A318/A319/A320/A321

TITLE : AIR CONDITIONING - AVIONICS EQUIPMENT GROUND COOLING - DEACTIVATE THE
GROUND REFRIGERATION UNIT (GRU).

MODIFICATION No. : 33129P8139

SERVICE BULLETIN No. : A320-21-1148

Figure 7 Sheet 1
Modification of the Connectors in the Avionics Compartment

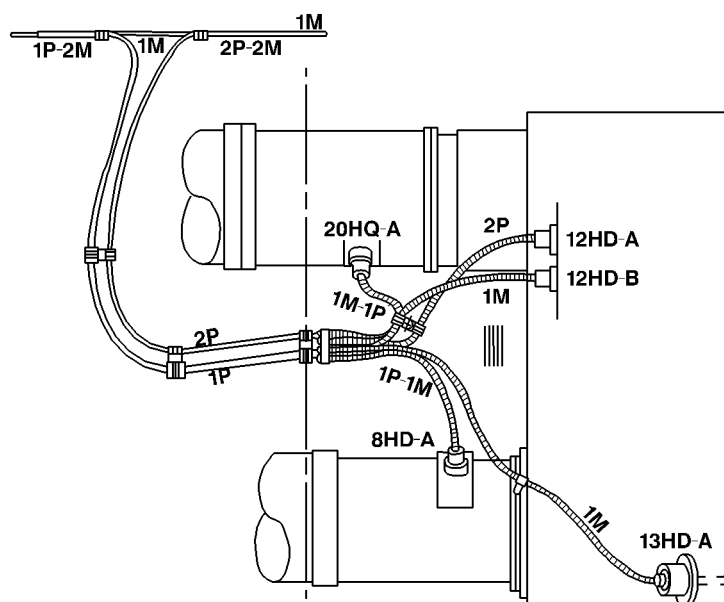
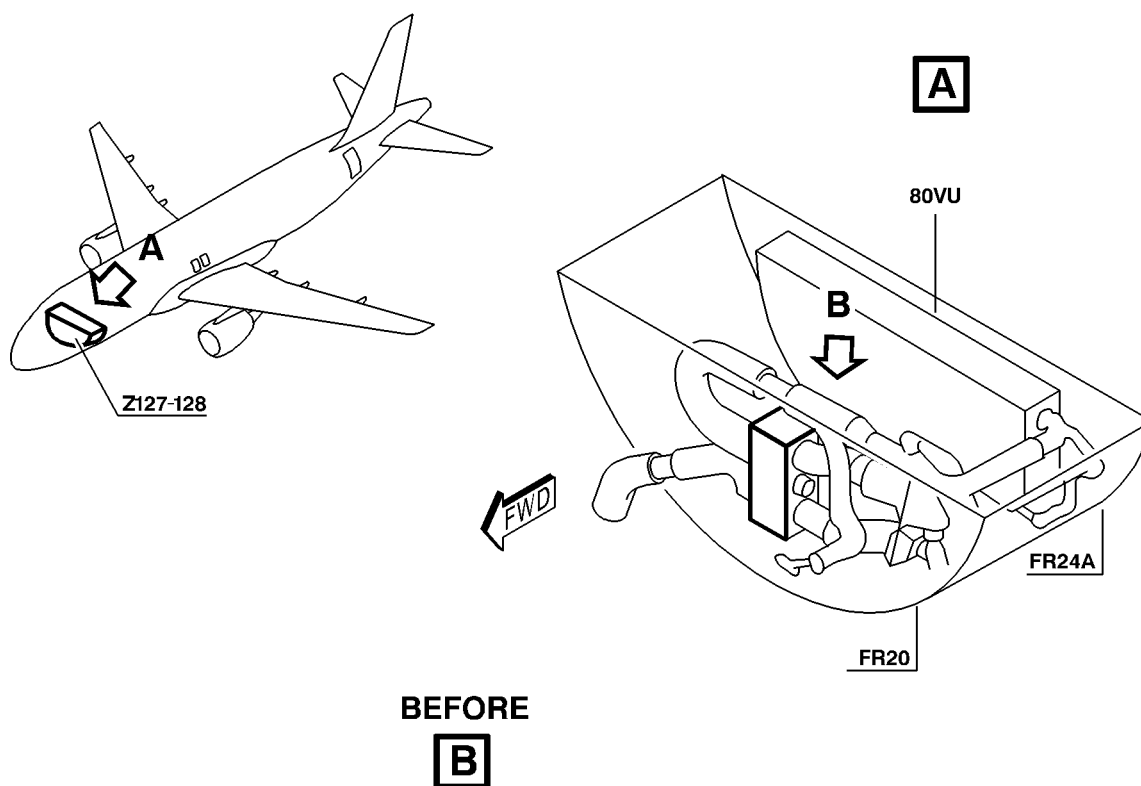
Refer to figure 7 Sheets 1 and 2

Figure 8 Sheet 1
Modification of the Equipment in the Cockpit

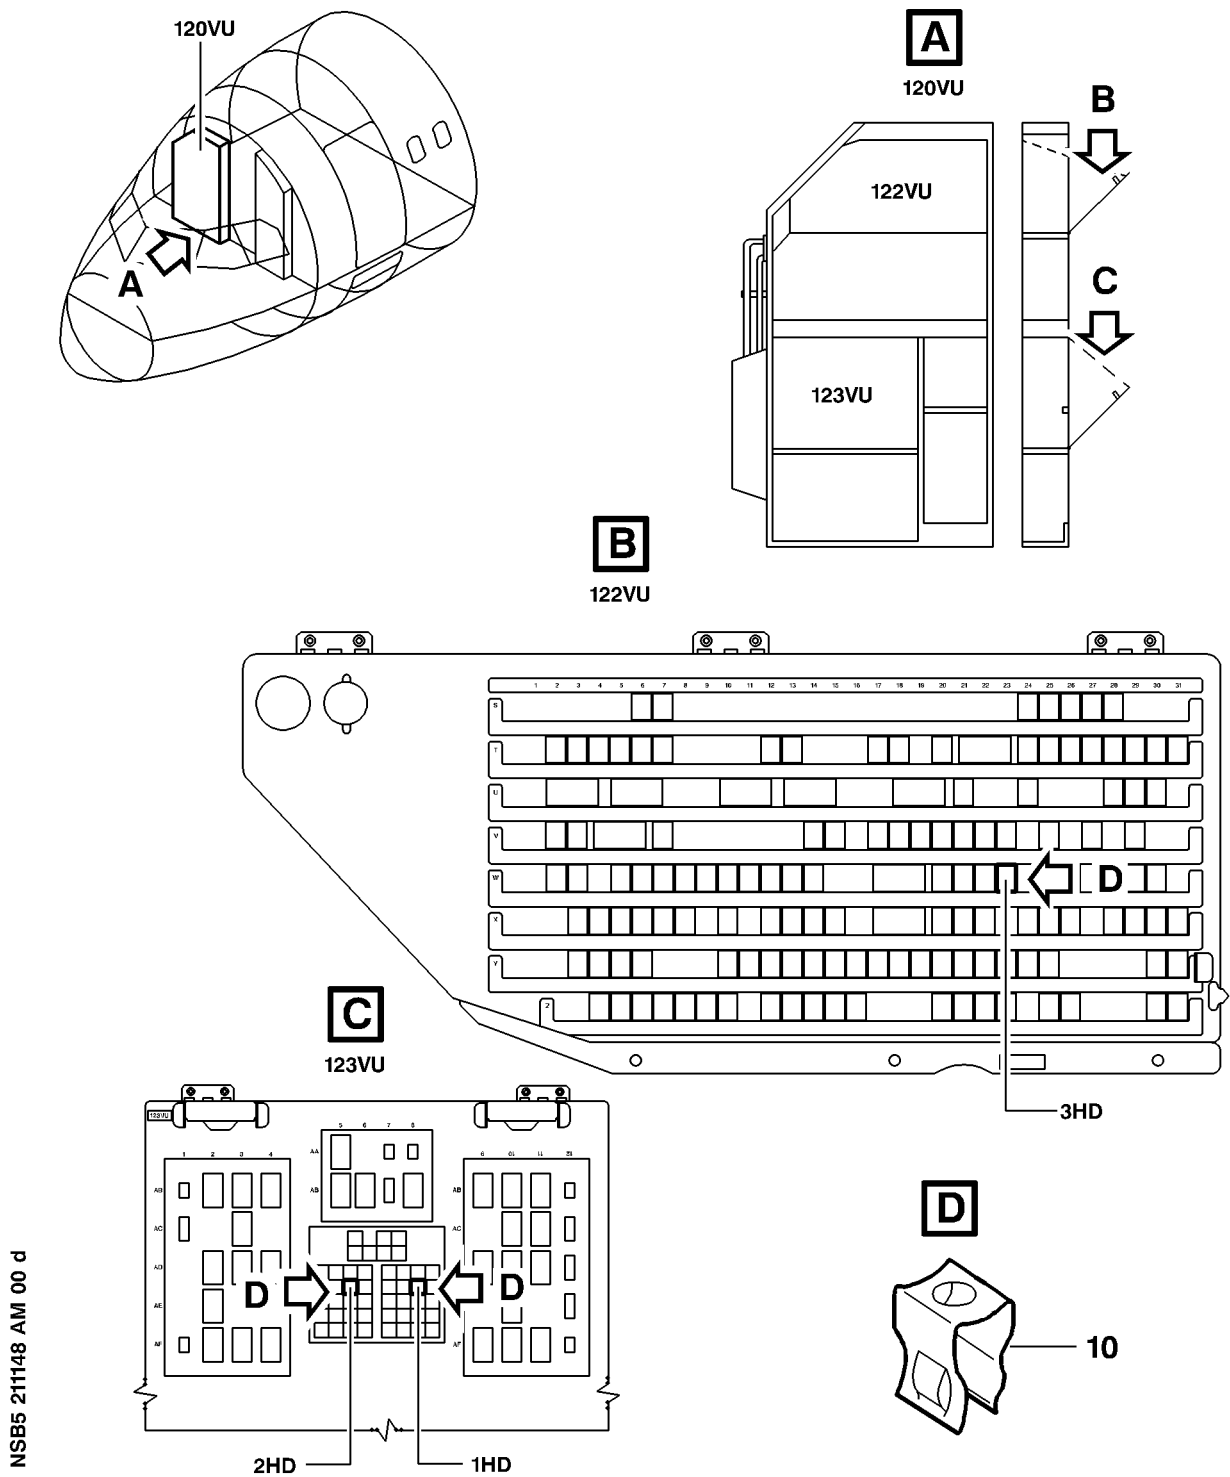
Refer to figure 8

Figure 9 Sheet 1
Modification of the Integrally Lighted Plate (9LF), on the Overhead Control Panel 22VU

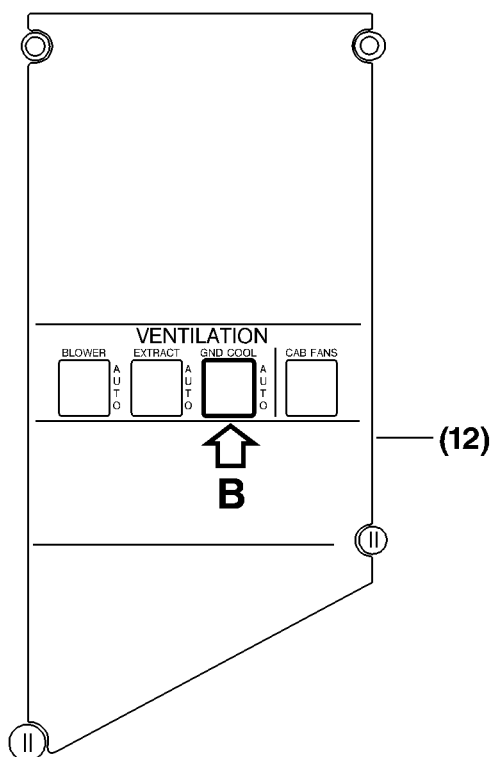
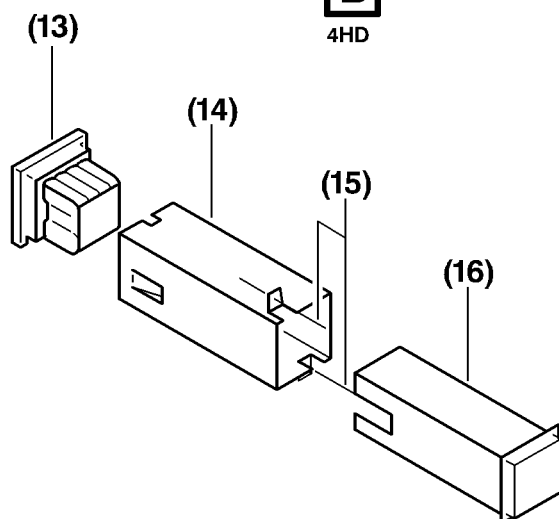
(a) Remove the overhead control panel 22VU.

Refer to figure 9 Sheet 1

Figure 10 Sheet 1
Modification of the Wiring in the Overhead Control Panel 22VU (Config. 01)

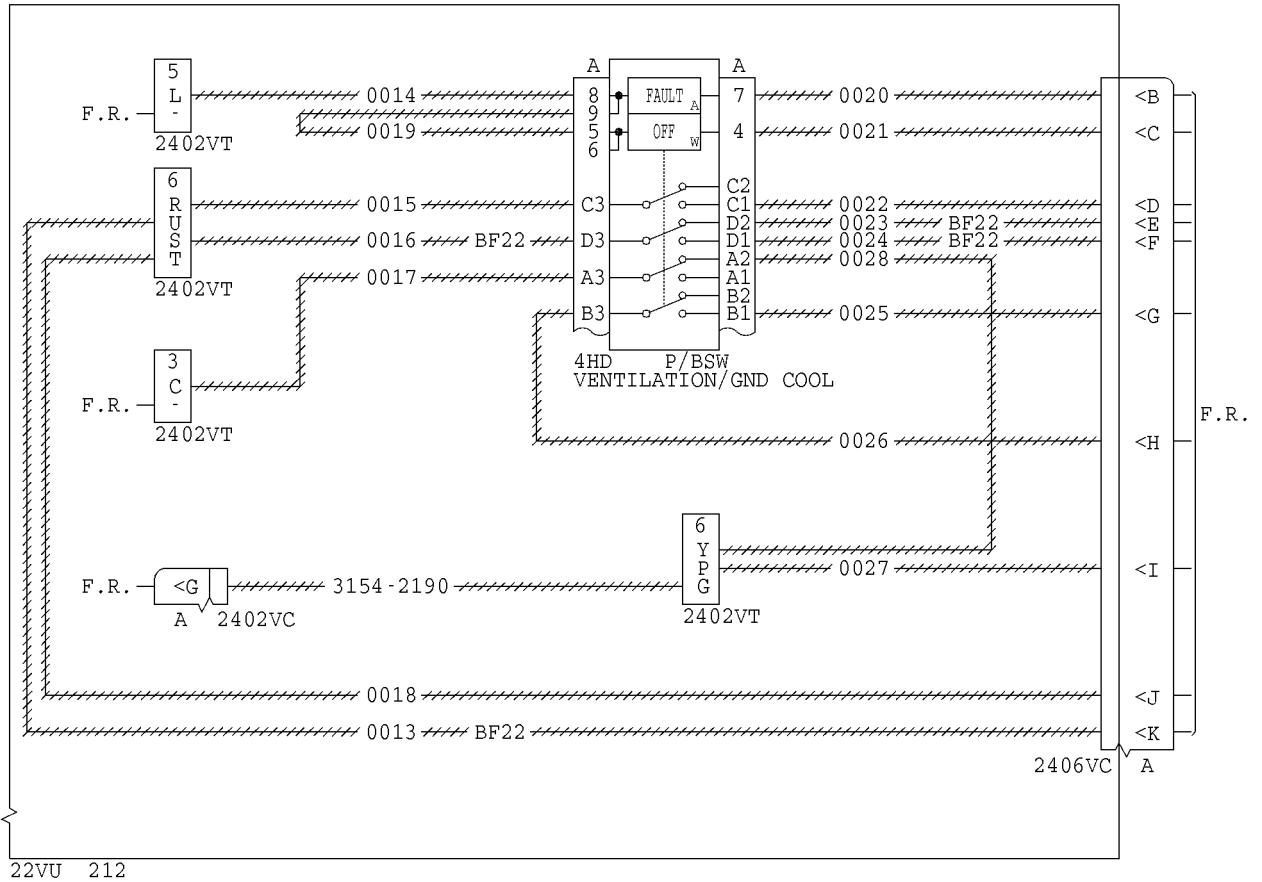
Refer to figure 10

Figure 12 Sheet 1
Modification of the Wiring in the Shelf 88VU

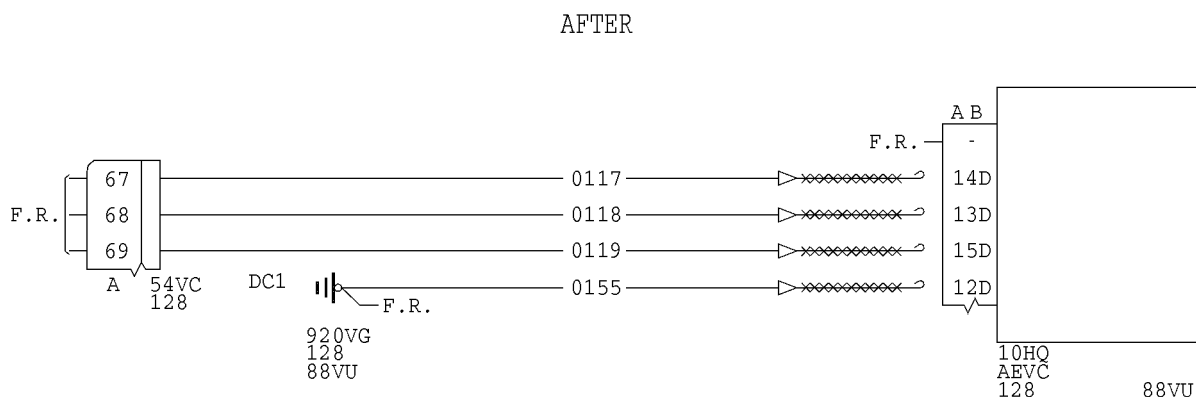
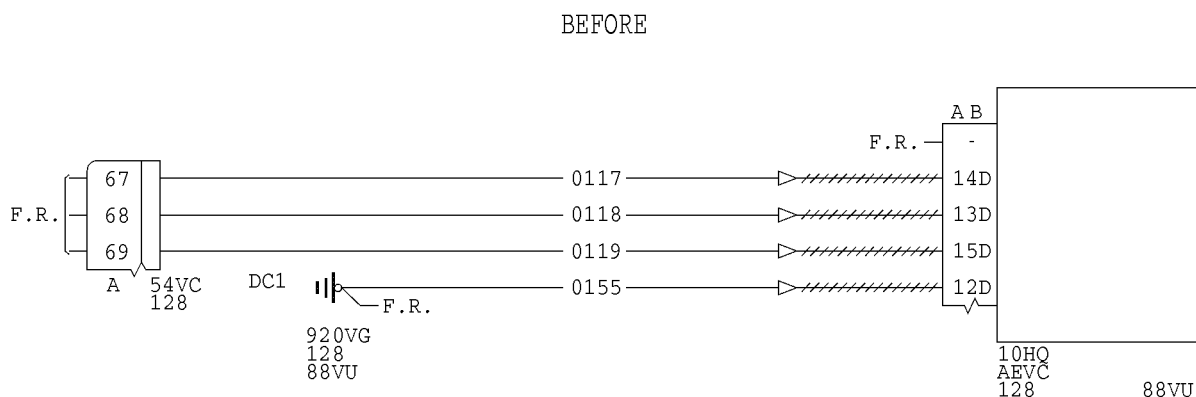
Refer to figure 12

1 Modify the connection of the wires shown on the lines 1 thru 8 (Refer to figure 18).

Figure 13 Sheet 1
Modification of the pin Programming of the SDACs

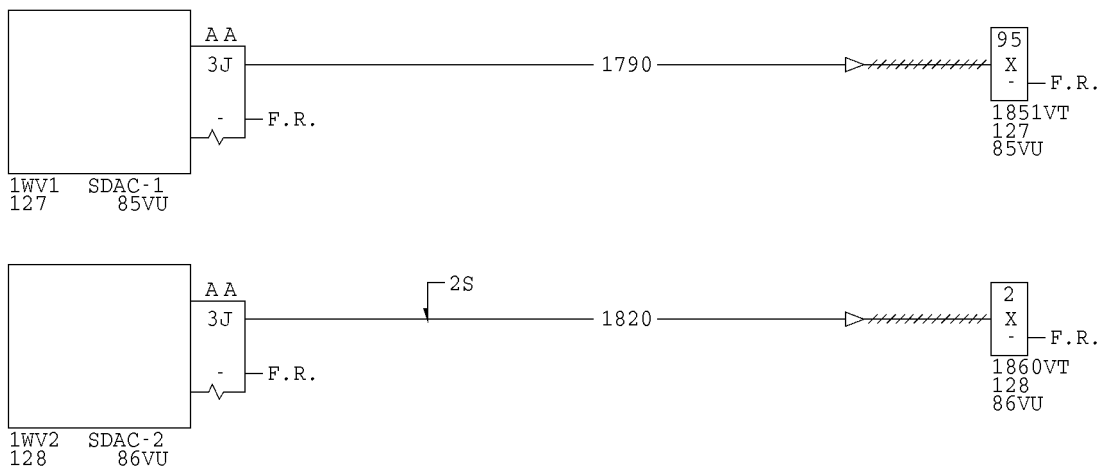
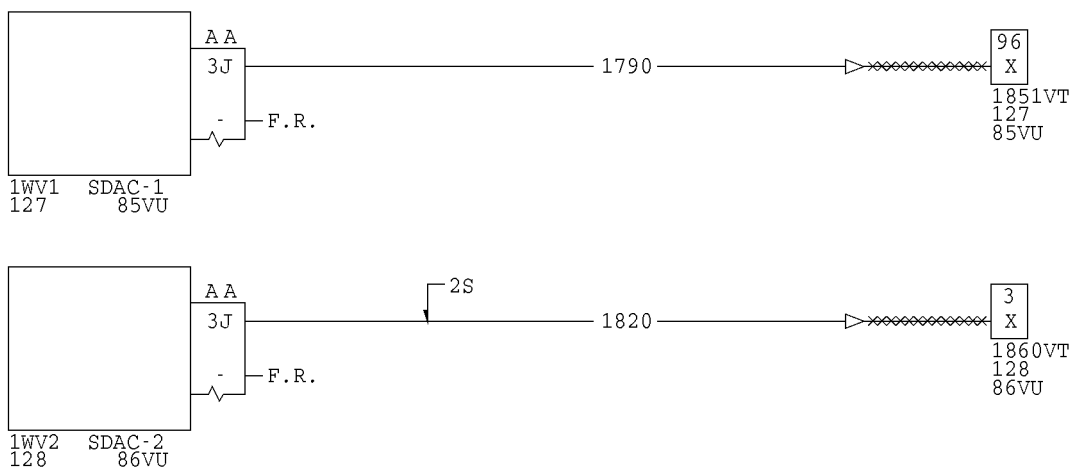
Refer to figure 13

a Modify the connection of wires shown on the lines 1 thru 4 (Refer to figure 19)

Figure 14 Sheet 1
 Modification of the Parity of the SDACs

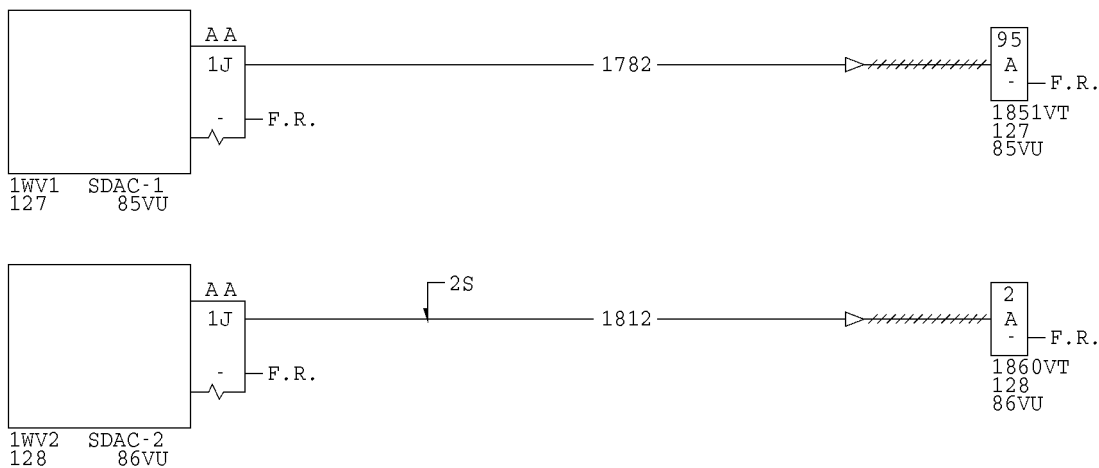
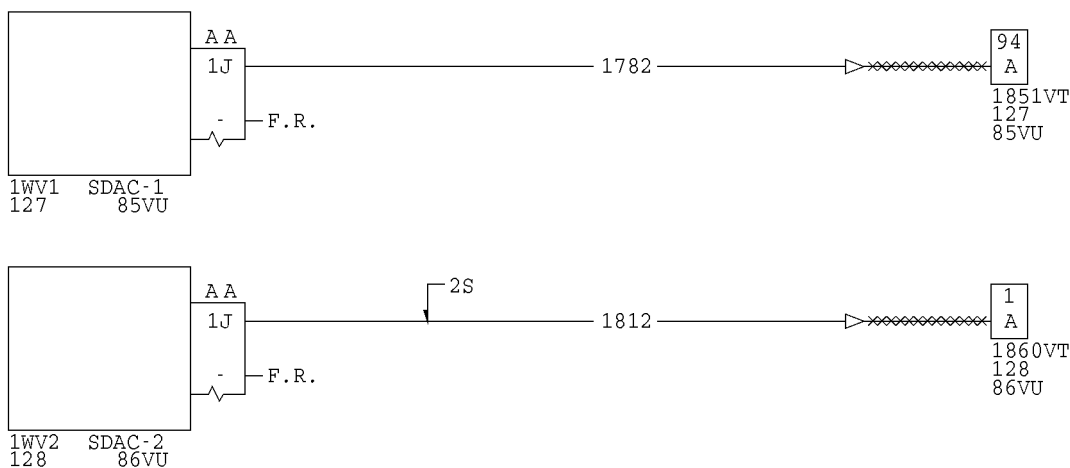
Refer to figure 14

a If during accomplishment of para. 3. A.(1) (e) you noted that the existing aircraft wiring correspond to lines 1 and 3 of figure 20 :

Figure 15 Sheet 1
Modification of the Parity of the SDACs

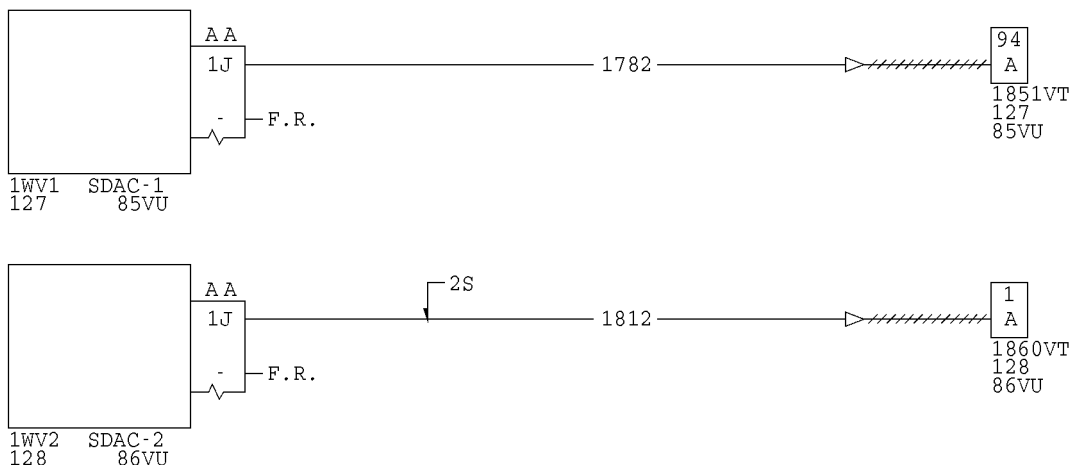
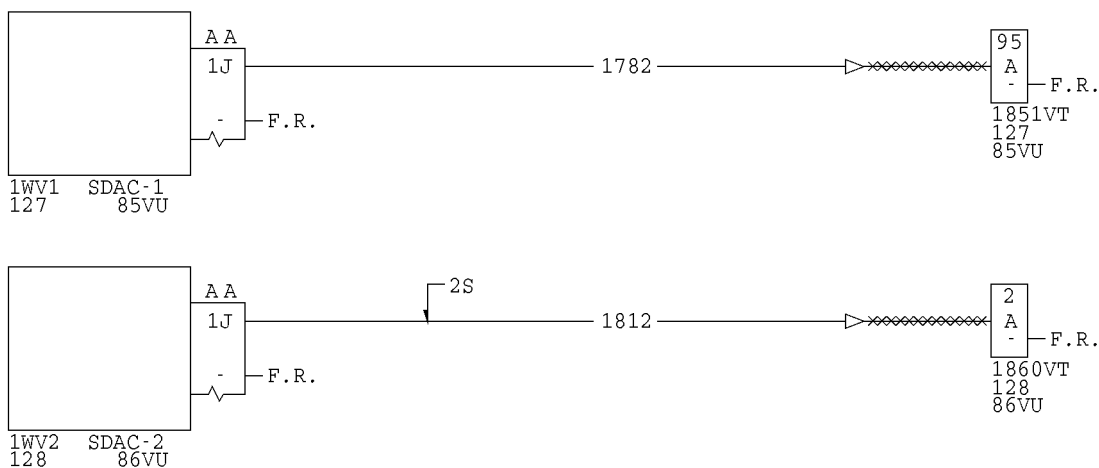
Refer to figure 15

- b If during accomplishment of para. 3. A.(1) (e) you noted that the existing aircraft wiring correspond to lines 1 and 3 of figure 21 :
